Subject: Turkey Point Units 3 and 4
Docket No. 50-250 and 50-251
Response to Request for Additional Information (RAI)
Regarding Third 10-year Inservice Inspection Interval Relief Requests 1A, 14A, 15A

RESPONSE TO REQUEST FOR ADDITIONAL INFORMATION
TURKEY POINT UNITS 3 AND 4
RELIEF REQUEST NOS. 1A, 14A, AND 15A
DOCKET NOS. 50-250 AND 50-251

**TURKEY POINT UNITS 3 AND 4
THIRD 10-YEAR INSERVICE INSPECTION INTERVAL
RELIEF REQUEST NUMBER 1A (Revised) Rev 1**

RPV Lower Head Ring-to-Bottom Head Weld (3-WR-9 and 4-WR-9)
Figure 1

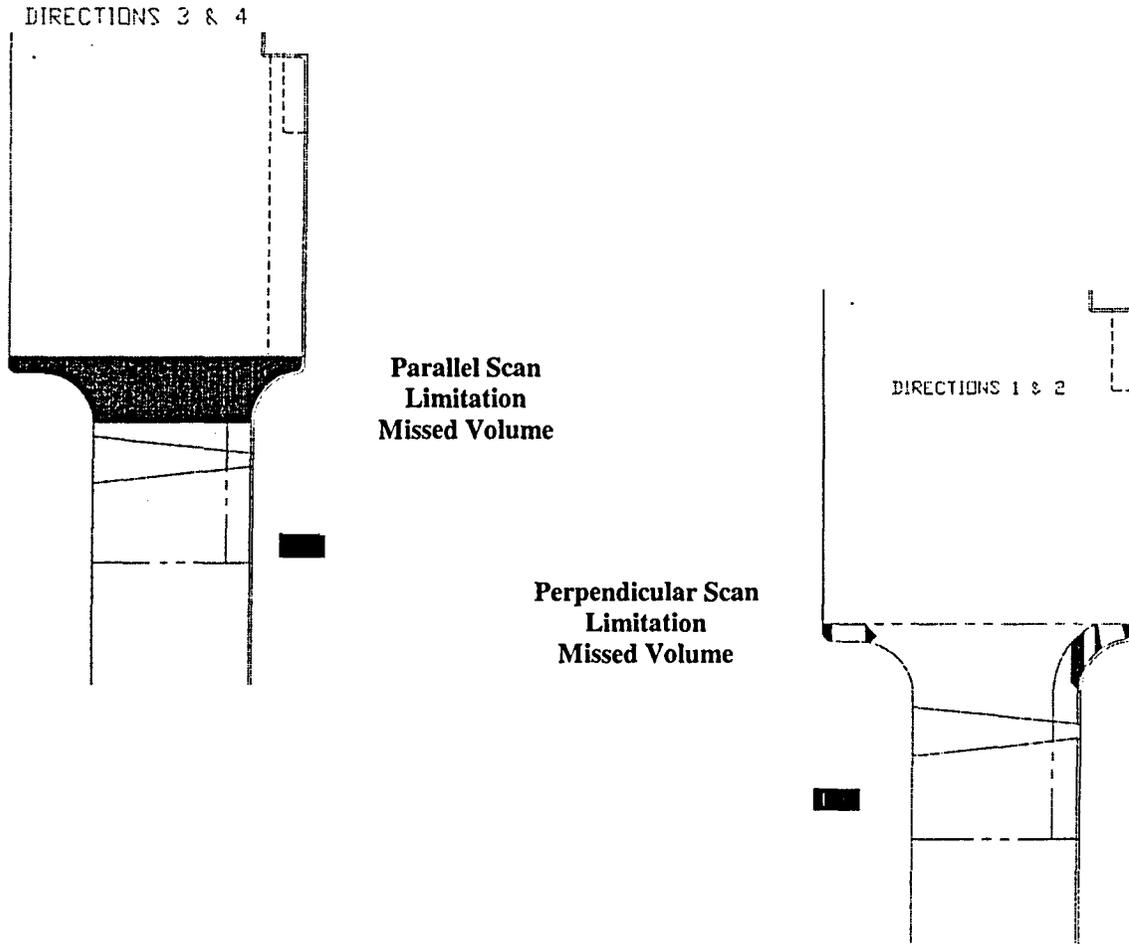
The examination of the Figure IWB-2500-3 A-B-C-D volume is limited due to the proximity of the instrumentation tubes. Access to approximately 17% of the examination volume is restricted. The remaining 83% of the examination volume was examined with techniques which have been qualified by demonstration in accordance with Supplements 4 & 6 of the 1995 Edition, 1996 Addenda of the ASME Code Section XI, Appendix VIII, using the Performance Demonstration Initiative Protocol. This weld was examined from both sides of the weld, scanning both parallel and perpendicular to the weld. The ultrasonic examination identified no recordable indications.

The mechanized scanning of the lower head ring-to-lower head welds 3-WR-9 and 4-WR-9 are limited due to interference from the instrumentation tubes. Figure 1 provides an illustration of the weld volume limitation due to the instrumentation tubes.

Upper Shell to Flange Weld Volume Limitation Illustration
Figure 2

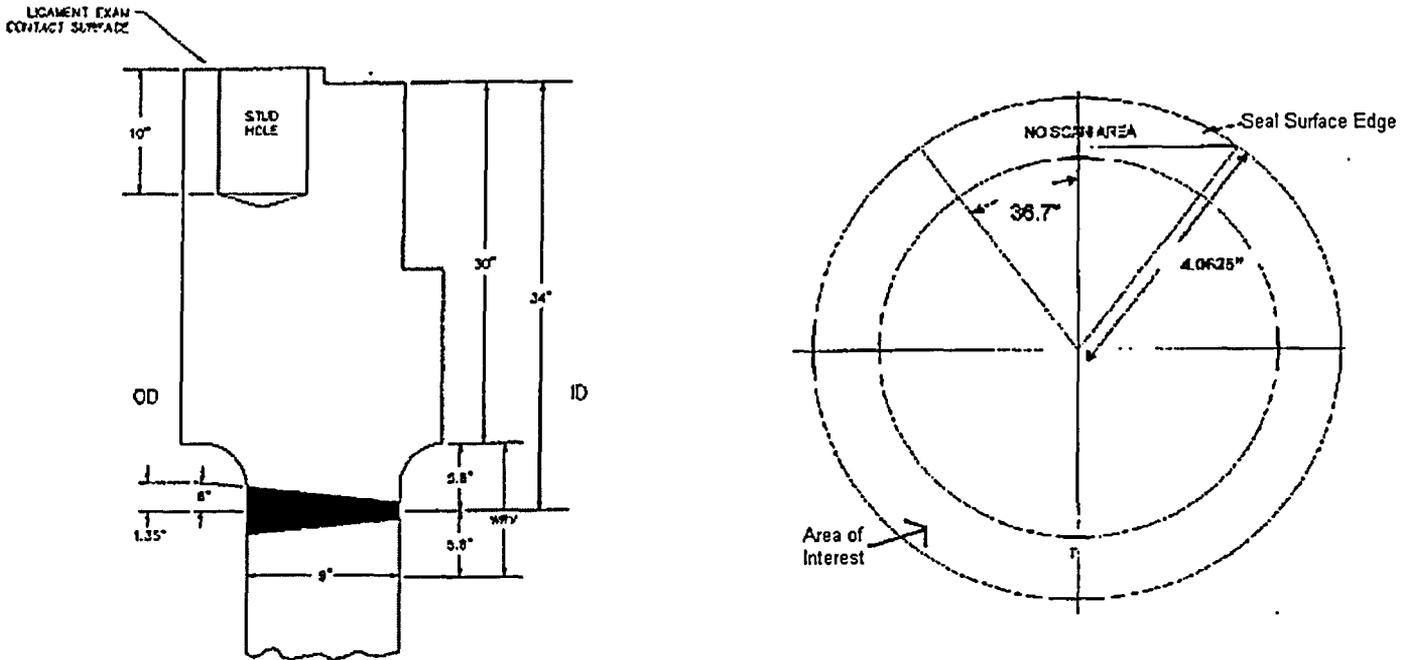
The examination of the Figure IWB-2500-4 A-B-C-D volume is limited due to the Keyways and Irradiation Slots. Access to approximately 29% of the examination volume is restricted. The remaining 71% of the examination volume was examined with ASME Code acceptable techniques. Additionally, the mechanized techniques employed for examination from the RPV inside surface have also been qualified by demonstration in accordance with Supplements 4 & 6 of the 1995 Edition, 1996 Addenda of the ASME Code Section XI, Appendix VIII, using the Performance Demonstration Initiative Protocol. This weld was examined from both sides of the weld, scanning both parallel and perpendicular. The ultrasonic examination did not reveal any recordable or reportable flaws in accordance with the ASME Code Section XI, 1989 Edition, No Addenda.

The upper shell-to-flange weld 3-WR-18 and 4-WR-18 is examined from the shell side and from the flange seal surface. The examination performed from the flange seal surface was not limited by configuration. Figure 2 shows the inside surface scan limitations and the location of the areas of incomplete coverage to the mechanized scanning due to the presence of the keyways and Irradiation slots.

Figure 4

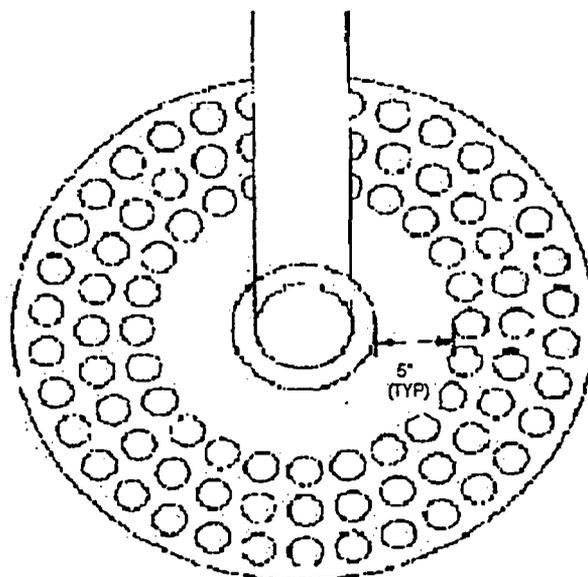
5. **In Relief Request 14, component 3-SRGN-01-IR is listed under examination category B-D, Item No. B3.120, which is applicable to the Pressurizer. In Relief Request 14A, component 3-SRGN-01-IR is listed as applicable to examination category B-D, Item No. B3.140. Please explain this change in classification of component 3-SRGN-01-IR.**

This is a typographical error. The examination category is B-D, Item No. B3.120.
